Re: **Docket No. 472 – Application of Cellco Partnership d/b/a Verizon Wireless for a Certificate of Environmental Compatibility and Public Need for the Construction, Maintenance and Operation of a Wireless Telecommunications Facility Located at 541 Broadbridge Road, Bridgeport, Connecticut**

On May 11, 2018, the Council approved the Development and Management (“D&M”) Plan for the tower site at 541 Broadbridge Road in Bridgeport. I write now, on behalf of Cellco Partnership d/b/a Verizon Wireless (“Cellco”) seeking staff approval for a modification to the approved tower foundation design.

In support of this proposed foundation modification, enclosed please find fifteen (15) sets of revised D&M Plans showing the proposed 12’ x 24’ underground tower foundation (Plan Sheet C-2) and new tower foundation design drawings and calculations prepared by Boris Fayman, Professional Engineer with Engineered Endeavors.

TOP VIEW & REINFORCEMENT

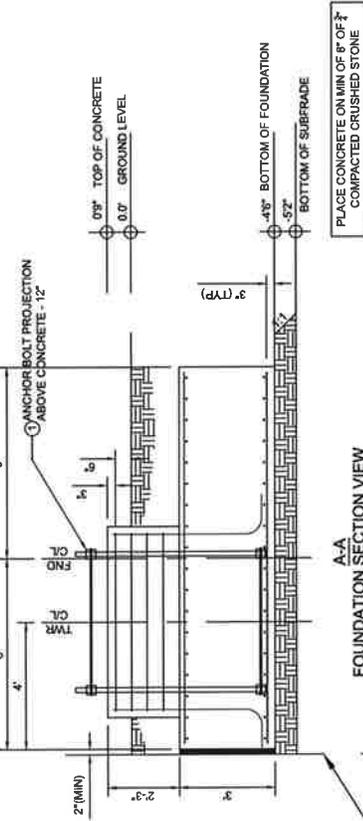
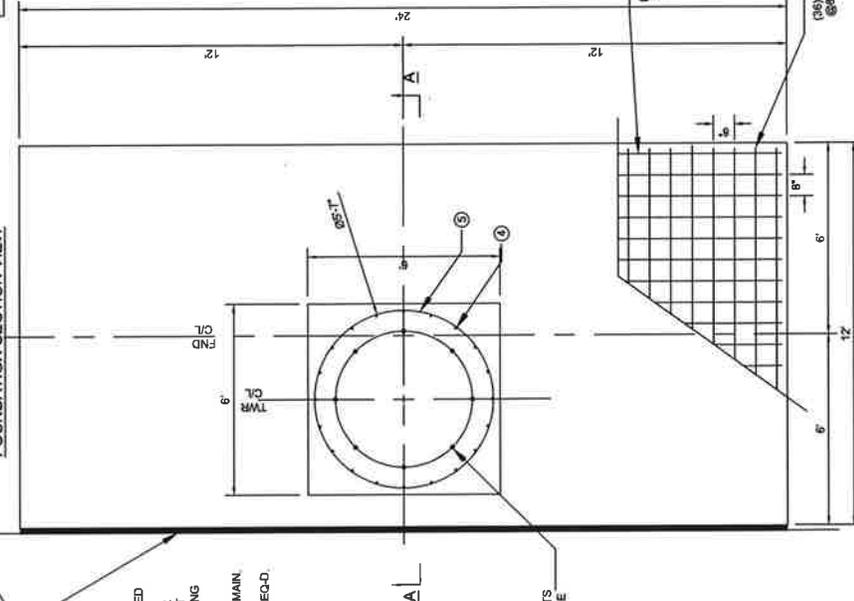
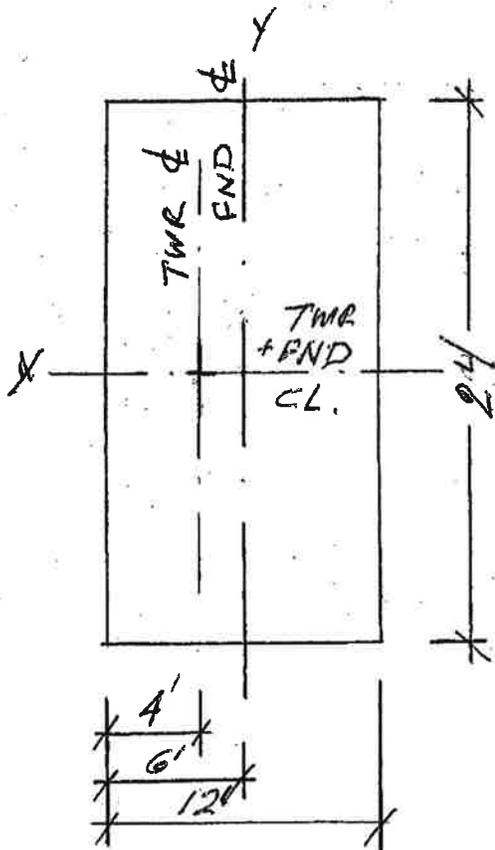
In an effort to reduce the potential impact of construction activity on neighbors and to control costs associated with this project, Cellco is seeking approval of a modified tower foundation design; eliminating the caisson foundation; and installing a 12’ x 24’ pad and pier foundation. The property owner has agreed to the modified foundation design and the expansion of Cellco’s leased area at the subject parcel. That portion of the concrete pad foundation, extending beyond the limits of the approved 8’ x 20’ facility compound, will be installed underground.
